SKYLINE COLLEGE

STUDENT SUPPORT & COMMUNITY SERVICES CENTER AND SCIENCE ANNEX BUILDING

DSA INCREMENT ONE SUBMITTAL

OCTOBER 21, 2004 PROJECT RECORD DOCUMENTS

DRAWING TITLE: BUILDING B - FIRST FLOOR PLAN
 DATE: 10.21.04
 PROJECT # 04043
 SHEET NUMBER: SB2.01

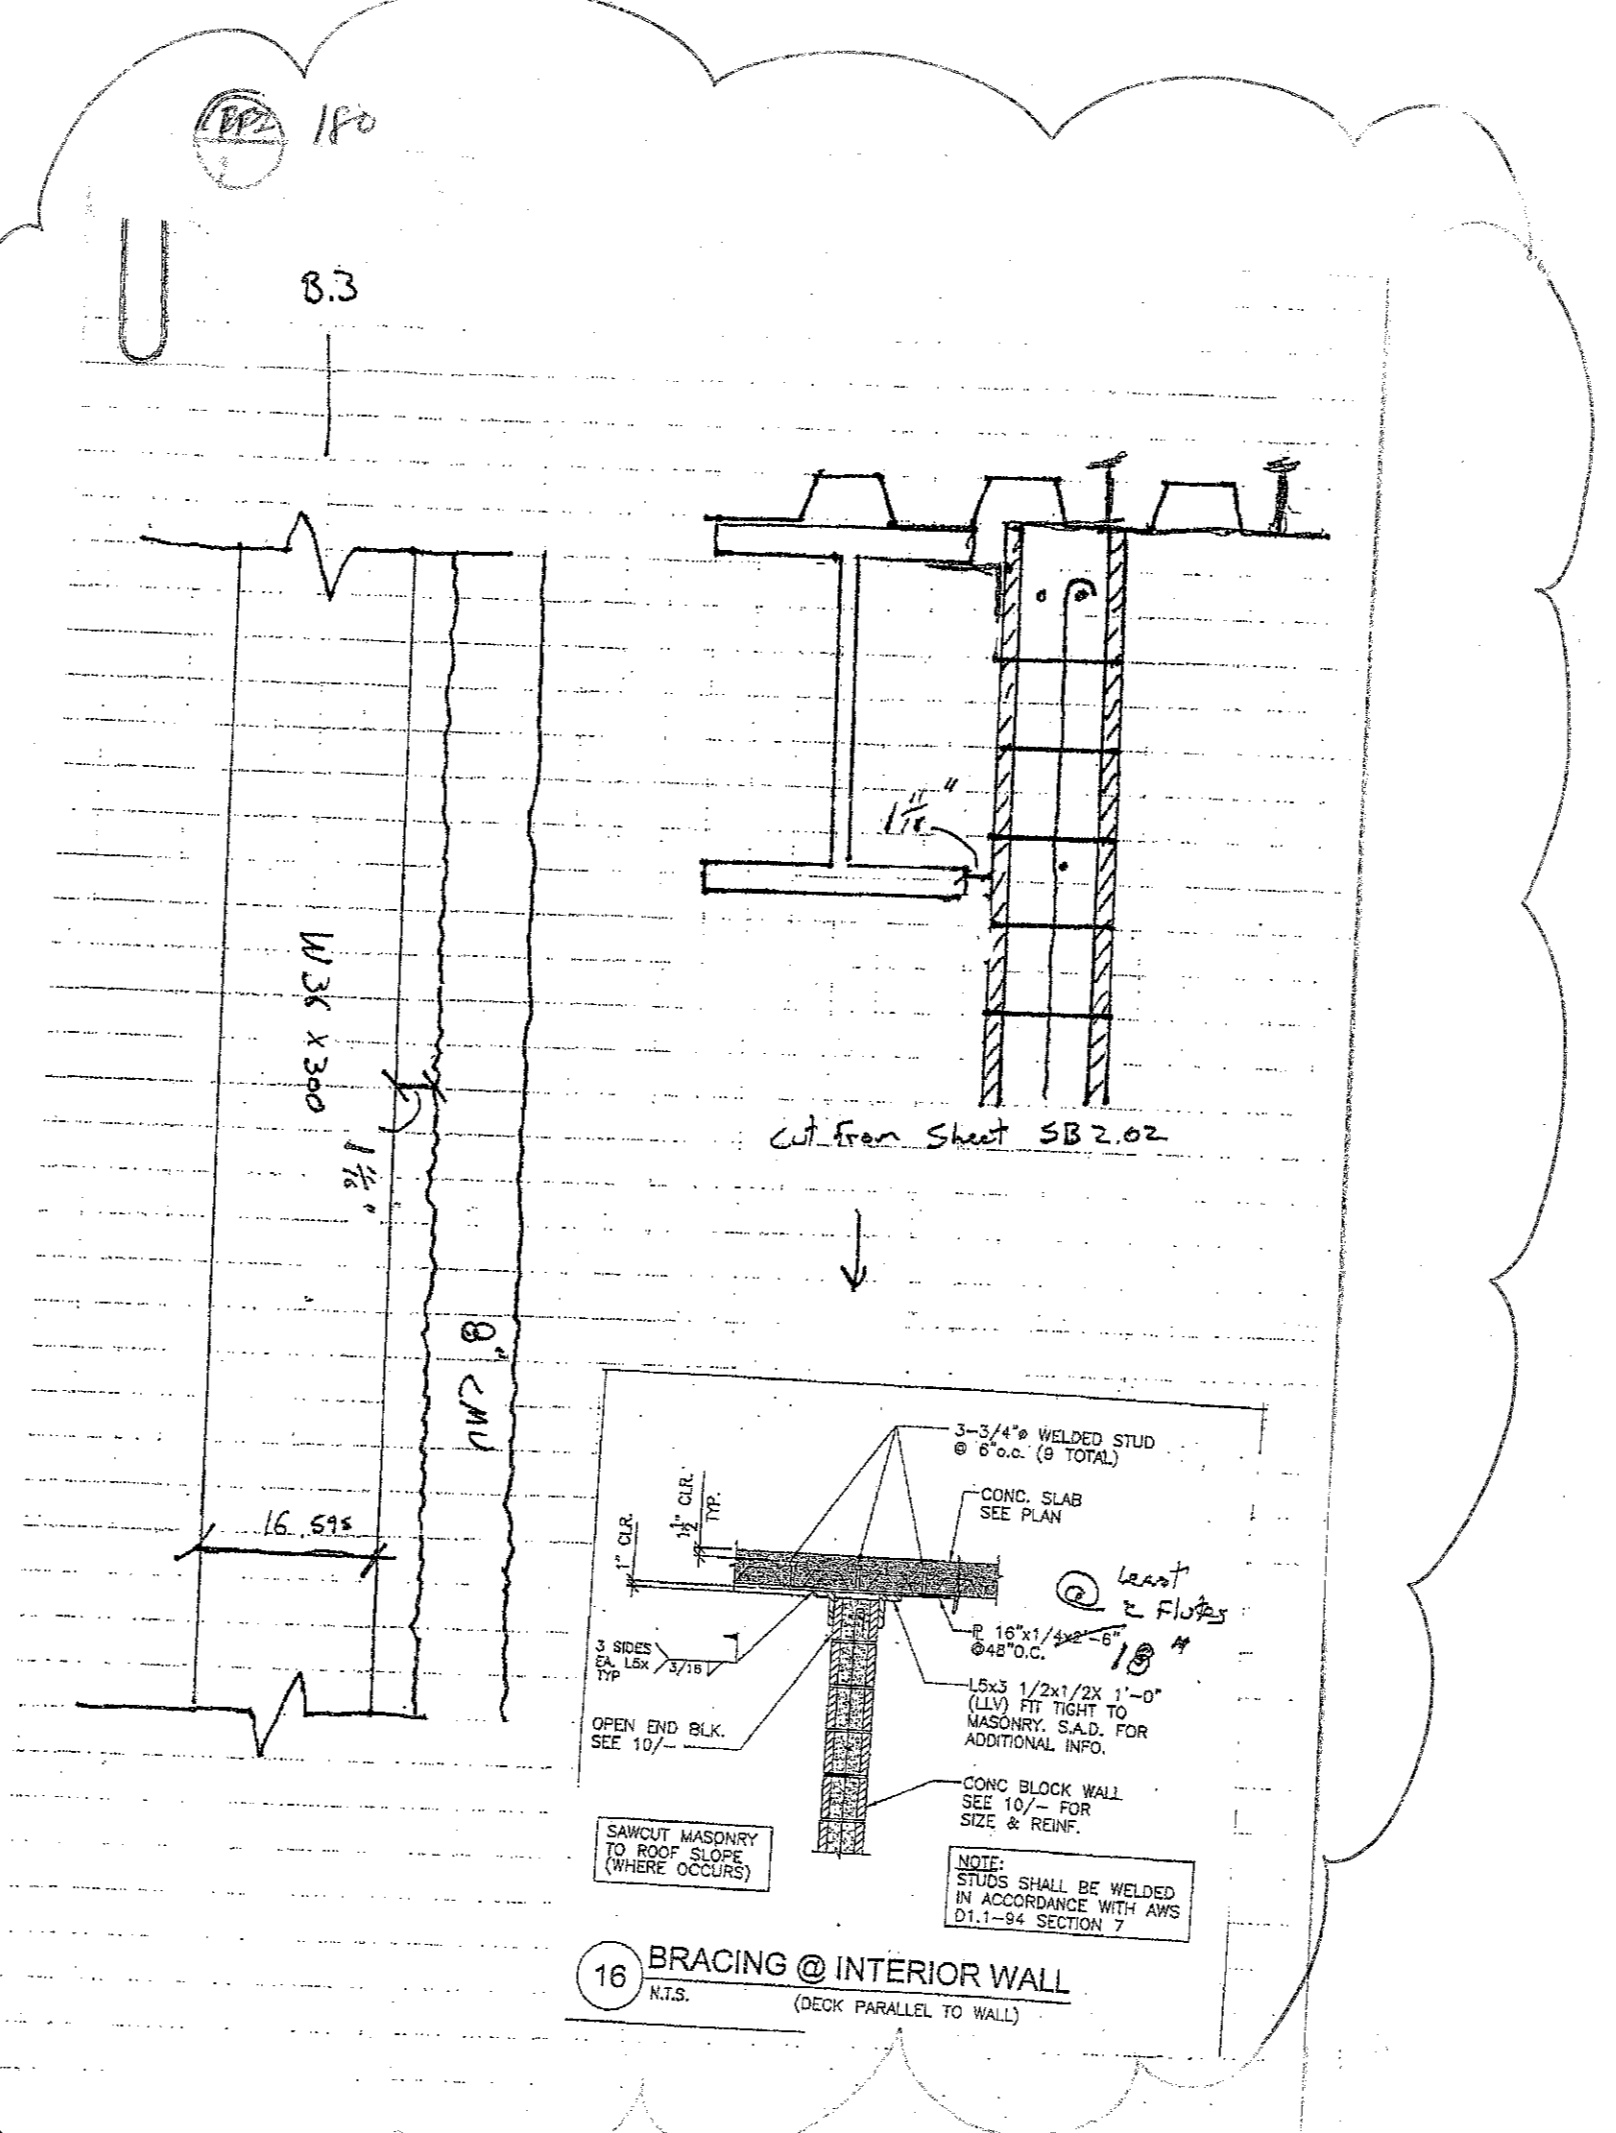
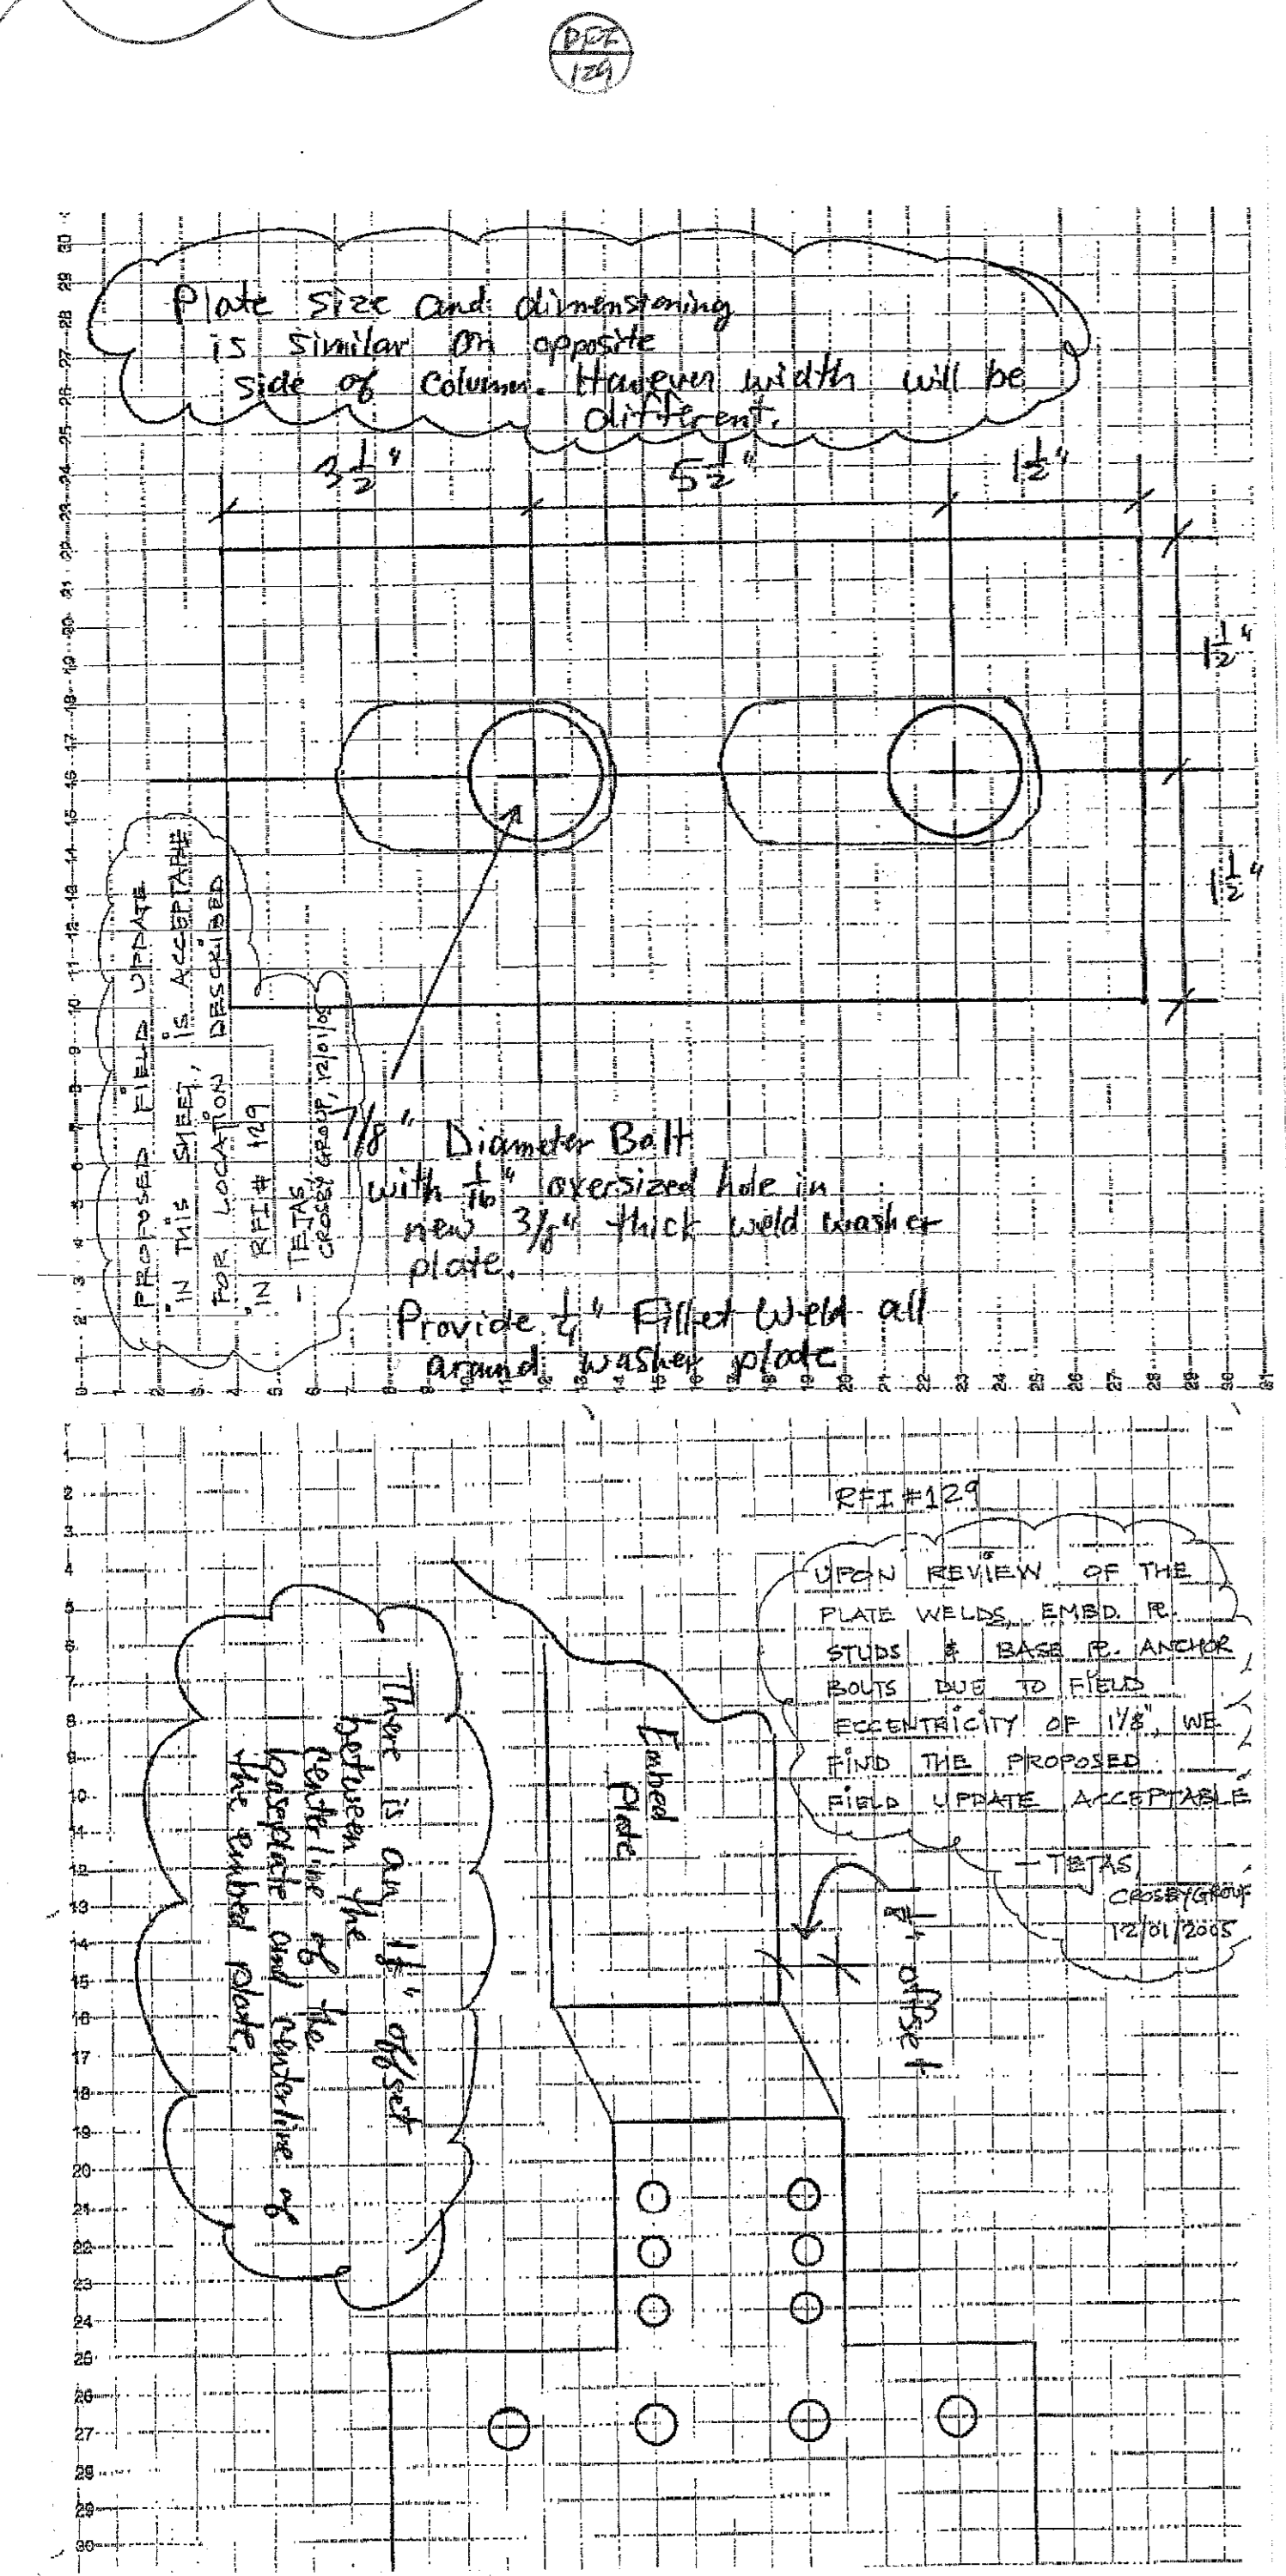
Question
Reference Sheet SB2.01 and Sketch A

DRAWING TITLE
BUILDING B - SECOND FLOOR FRAMING PLAN
DATE: 10.21.04
PROJECT # 04043
SHEET NUMBER
SB2.02

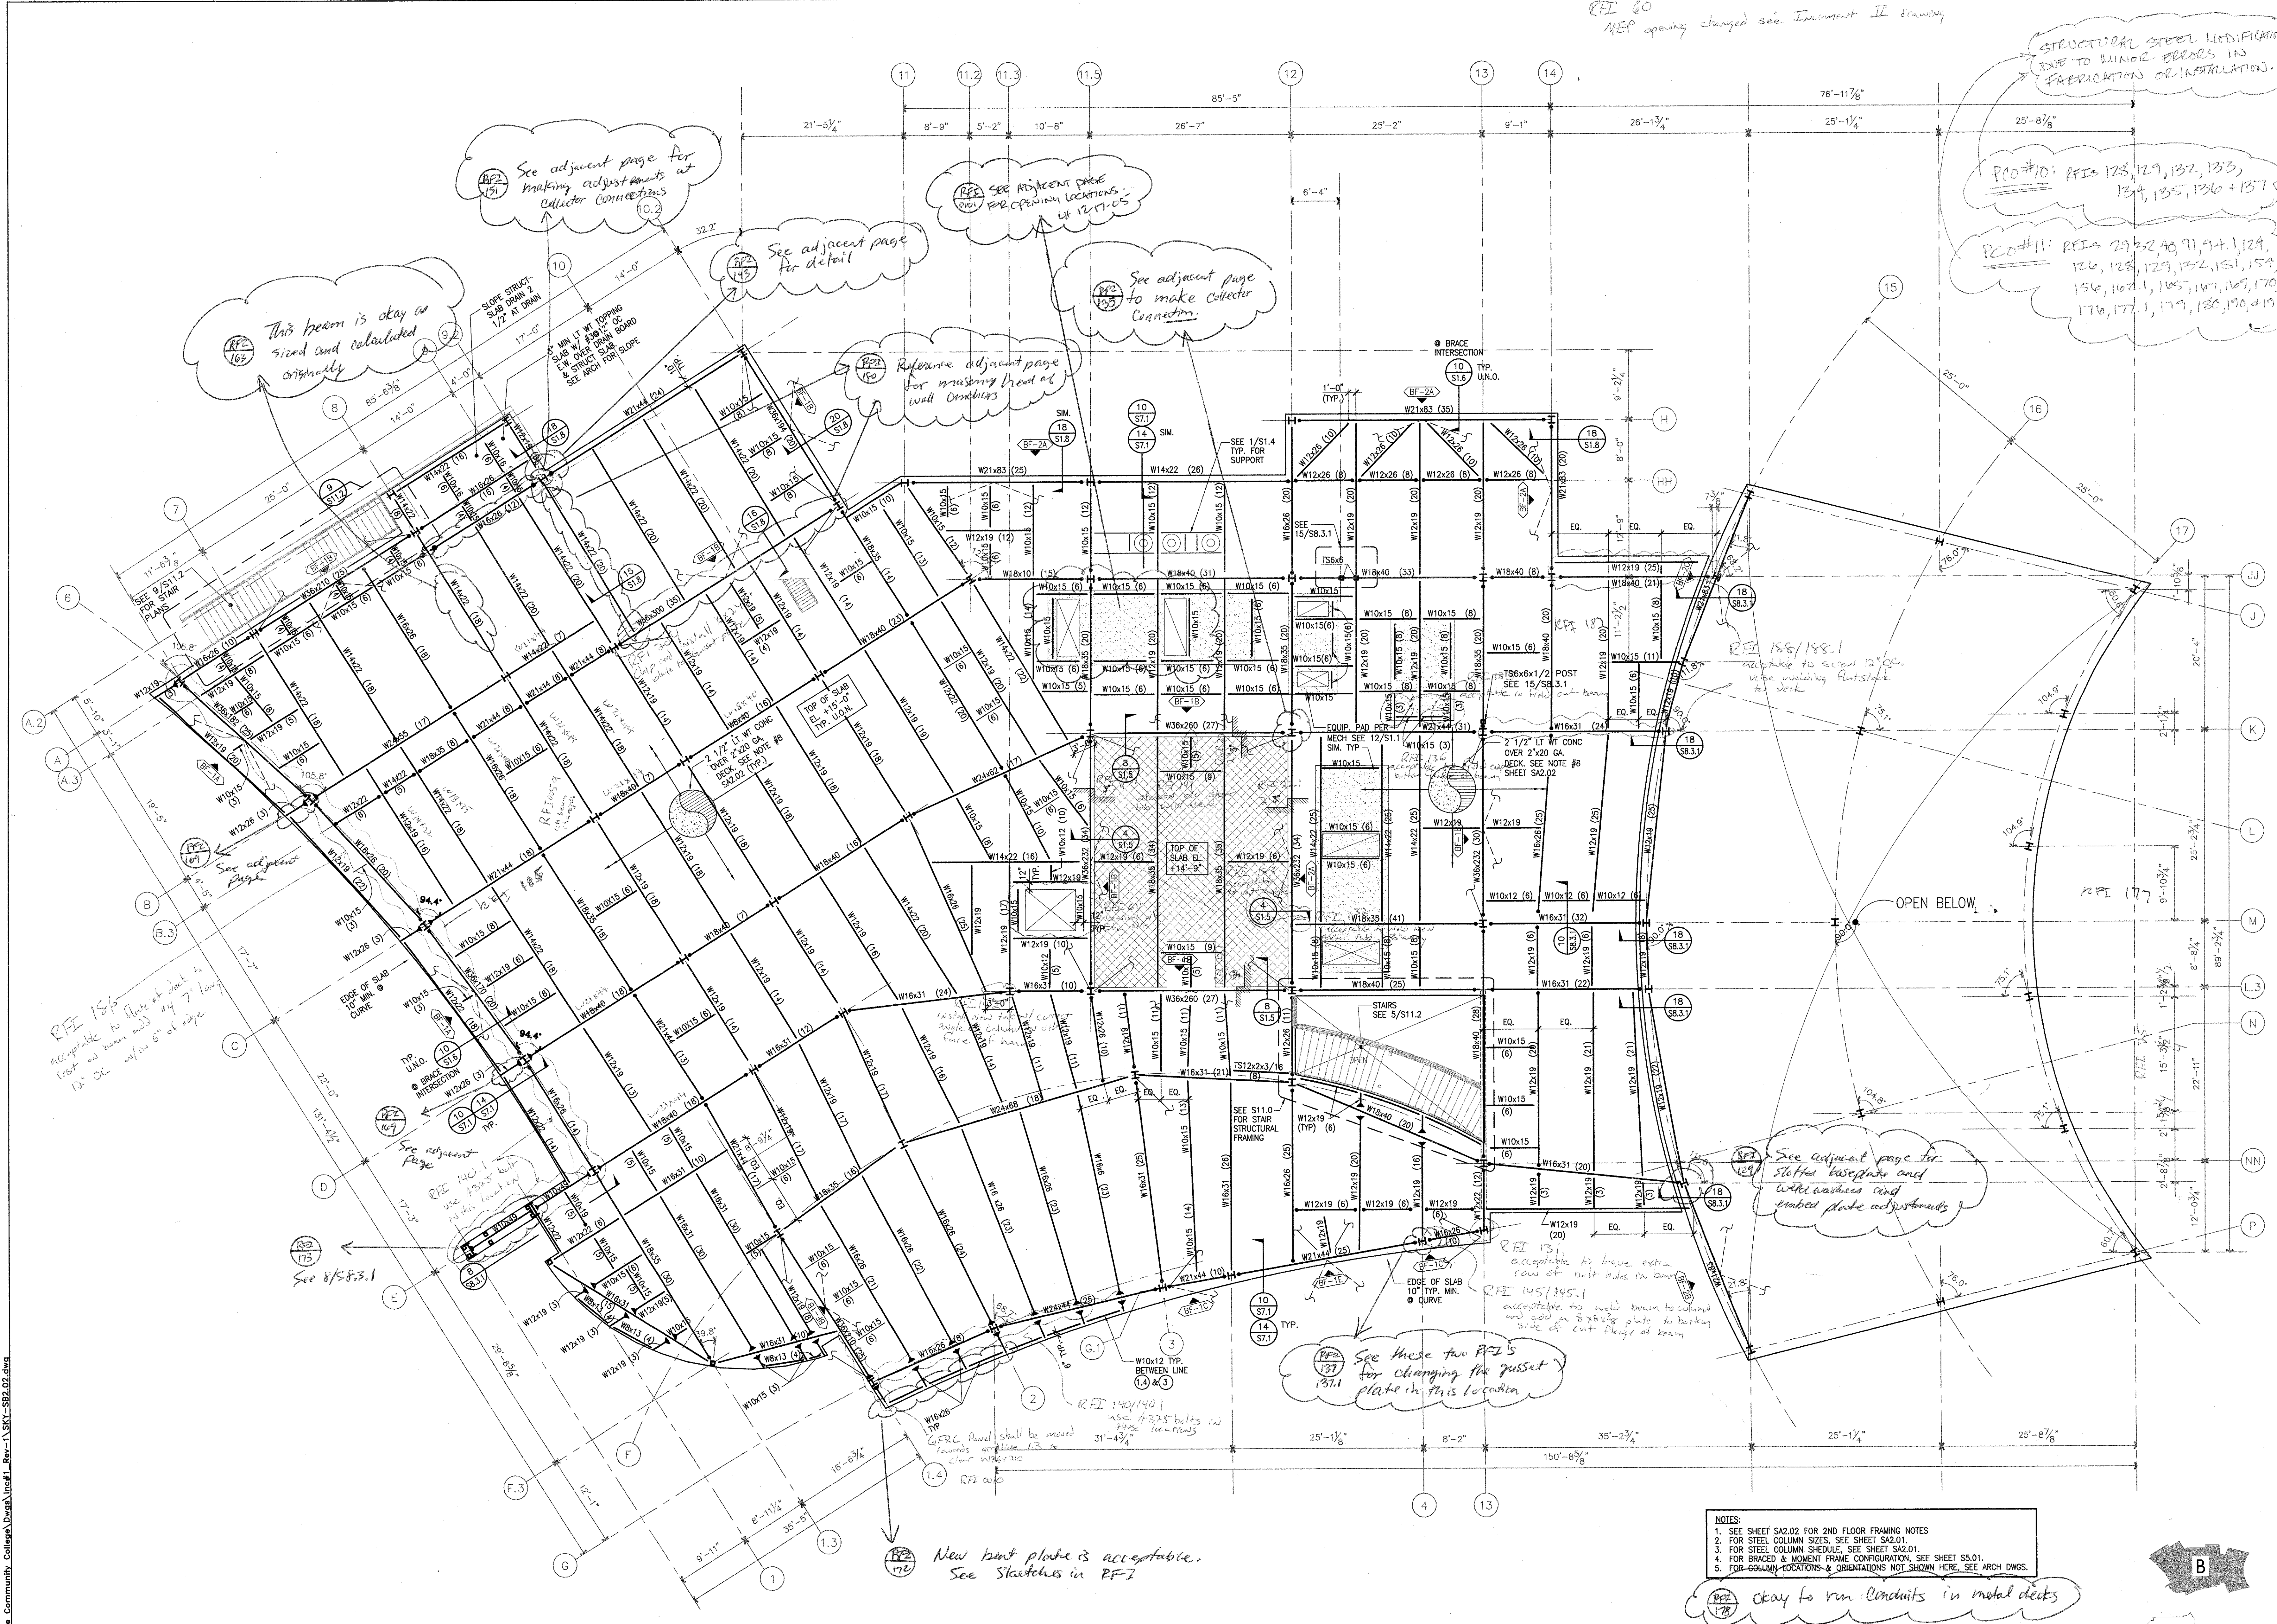
Question
 Reference Increment One drawings, sheet SB2.02 as well as Bambacigno Shop drawings. See also attached sketch.
 Along gridline 6 of building 6 there are several cantilevers that extend to the west to support the outermost beams. On the south edge of these cantilevers at gridlines 6/B and 6/C, the web from the incoming beam has been bent slightly in order to bolt up flush with the shear tab. These beams bolting into the cantilevers are beams A2355 and A2234.
 The inspector is concerned with this bending of the web and its affect on the beam and its connection to the cantilever at these locations.
 Please clarify if this issue is a problem; if so, please offer any steps that may be needed in order to make corrections.
Consultant Comments
 It is NOT acceptable to have bent steel plates. This may have yielded the beam web and potentially damaged shear tab too. Please do following: A. cut and replace existing shear tab plate attached to cantilever beams, B. cut web extension plate from W12x long beam west of line 6, C. attach a new 3/8" thick x 12" long x 10.5" deep web-extension plate to web of this beam with a 5/16" fillet weld on three sides, 7" at top horiz., 10.5" vert., and 7" at bot horiz. D. The new web-extension plate should have required holes to match shear tab plate holes per design drawings. ... Tejas, CrosbyGroup.
